**RE: Response to USEPA Review of the Response to the October 23, 2015 USEPA  
Comments on the Vapor Intrusion Decision Flowchart**  
The Peoples Light and Coke Company, North Shore Gas Company, and Wisconsin Public  
Service Corporation

**RE: DRAFT - Response to USEPA Review of the Response to the October 23, 2015 USEPA Comments on the Vapor Intrusion Decision Matrix (flowchart)**  
The Peoples Light and Coke Company, North Shore Gas Company, and Wisconsin Public Service Corporation

Natural Resource Technology, Inc. (NRT) is providing for your use this letter response to USEPA comments dated December 17, 2015 on the Vapor Intrusion Investigation Decision Matrix ("flowchart"), Multi-Site Former MGP Program (NRT, November 23, 2015) for The Peoples Light and Coke Company (PGL), North Shore Gas Company (NSG), and Wisconsin Public Service Corporation (WPSC).

**Figure 1 – Vapor Intrusion Investigation Decision Matrix (January 15, 2016)**  
North Shore Gas; Peoples Gas, Light and Coke; and Wisconsin Public Service Corporation  
Multi-Site MGP Program

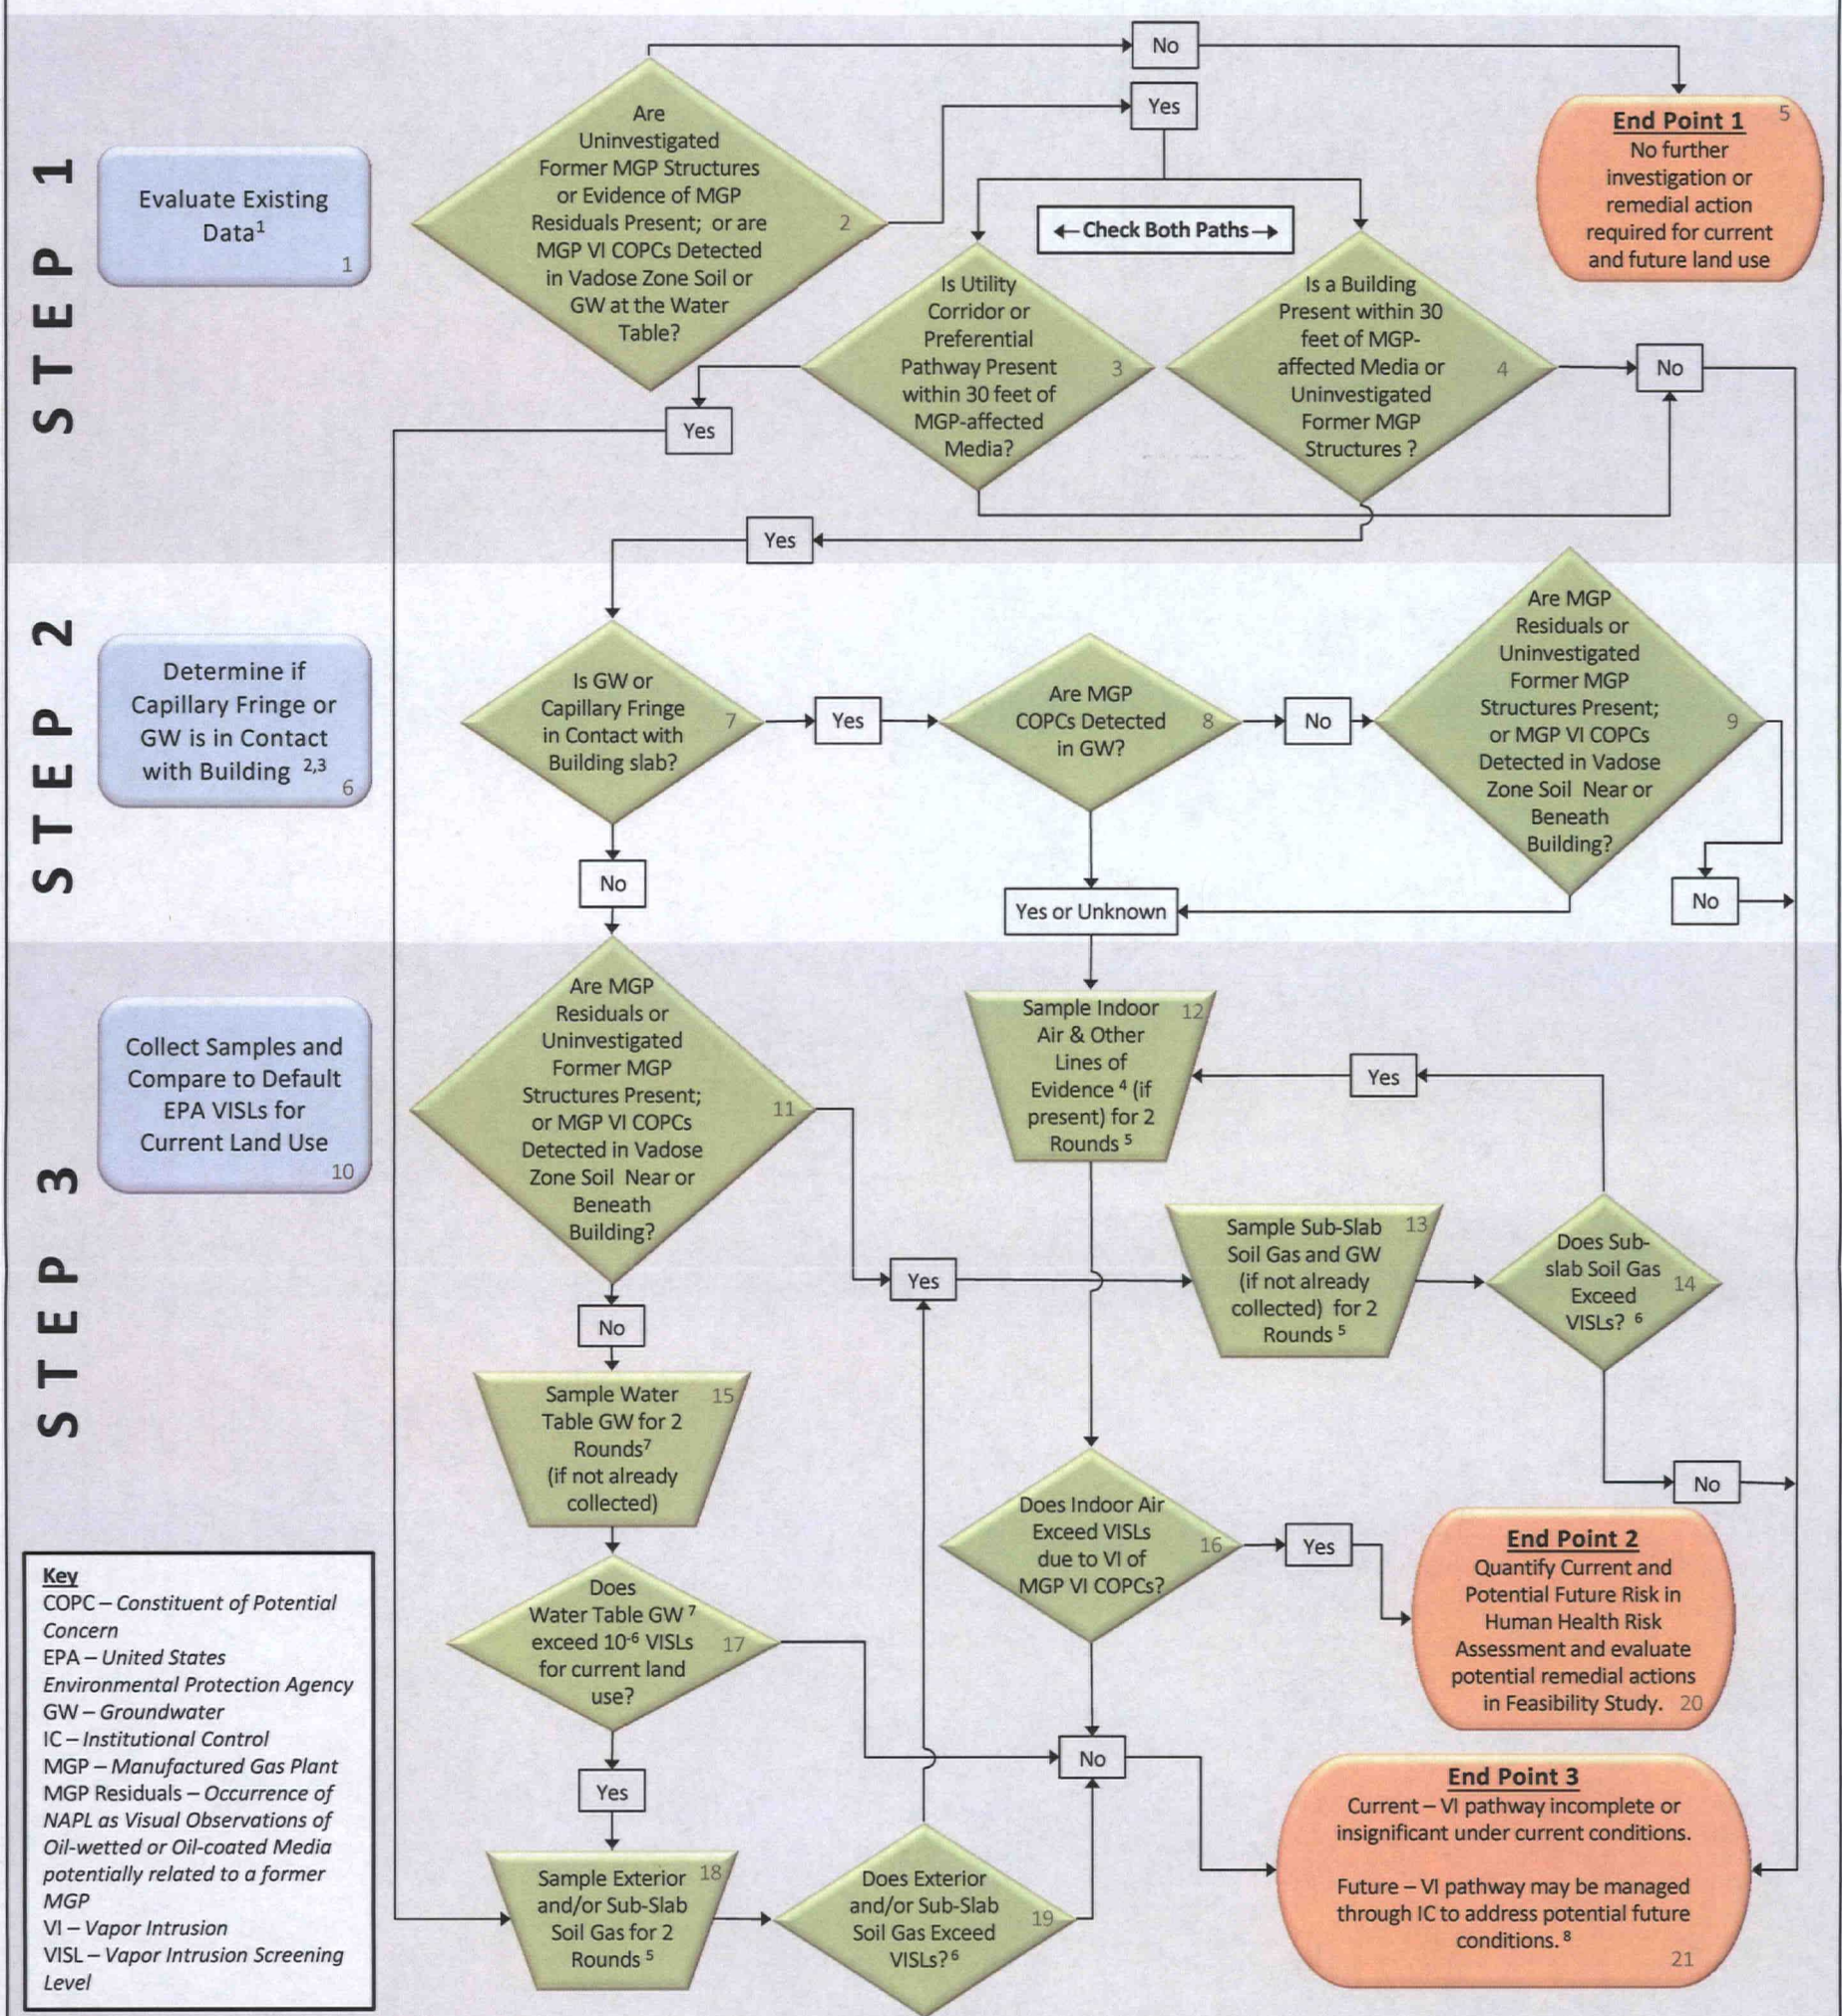
**Additional Caveat Relating to the WBS Response to Comment #20:** *It is not consistent with USEPA's 2015 VI Guidance or the NCP to use a blanket default institutional control (IC) approach for the future VI pathway in a generic flowchart process, without including flexibility for implementing a combination of remedial alternatives. For this reason, it is recommended that the Box for End Point 3 under "Future" read as follows:*

*"Future - Quantify risks using exterior and subslab data to determine the need for ICs. If future risks exceed targets, VI pathway may be managed through a combination of ICs, building mitigation, source remediation, or long-term monitoring, as practicable for the conditions at each site."*

**Original Comment 13.** *Step 3 indicates that if current indoor air concentrations < VISIs, the future VI pathway is managed through ICs. Also, if GW > VISLs but soil gas < VISLs, the future VI pathway can be managed through ICs. However, remedial action should not be limited to ICs and should consider other*

options (e.g., building mitigation, source removal, long-term monitoring), depending on the site. Refer to the flowchart for specific edits.

4. *Replace the word "shallow GW" in shape number 2 with "in GW at the water table"*

5. *Remove the word "shallow" from shape boxes 15 and 17 and replace it with "water table".*

6. *To capture the flow path for uninvestigated MGP structures, the following should be added to shape numbers 2 and 4: "uninvestigated MGP structures present near or beneath a building".*

7. *Key to Flow Chart: In the definition for MGP Residual, remove the D in DNAPL.*

8. *It is not clear in NRT's response to EPA comment #4 how VI COPCs in vadose zone soils are addressed on the flow chart. In the flow chart, "vapor intrusion COPCs in vadose zone soils" are specifically brought up in shape #2, follow through Shape #4 (covered under the term "MGP- affected media), but then drop out after shape #11 if it is not associated with "MGP Residuals or uninvestigated former MGP Structures". To capture this flow path, the following should be added to shape numbers 9 and 11: "are MGP COPCs detected in vadose zone soil within 5 ft of a building".*

**WBS Response:** There appears to be a misunderstanding between WBS and USEPA regarding under which situations institutional controls (IC) will be applied. There also appears to be a misunderstanding of how the ICs that WBS is proposing will trigger additional evaluation and potential remedial action, depending on future land and/or building use modifications.

**WBS Response:** Text modification has been completed, as requested.

**WBS Response:** Text modification has been completed, as requested

**WBS Response:** The phrase "uninvestigated former structures" has been added to boxes 2 and 4. The phrase "near or beneath a building" was not added to box 2 because this is an initial screening step to understand if there is a potential VI risk. The proximity of uninvestigated structures to buildings is not relevant at this step as it may result in prematurely reaching End Point 1. All uninvestigated structures, regardless of proximity to buildings, warrant investigation and/or institutional controls.

The phrase "near or beneath a building" was not added to box 4 because the box already contains text stating "Is a building present within 30 feet."

**WBS Response:** Text modification has been completed, as requested

**WBS Response:** The phrase "MGP VI COPCs Detected in Vadose Zone Soil" was added to boxes 9 and 11. The phrase "within 5 ft of a building" was not added to boxes 9 and 11 because the boxes already contain text stating "near or beneath building."
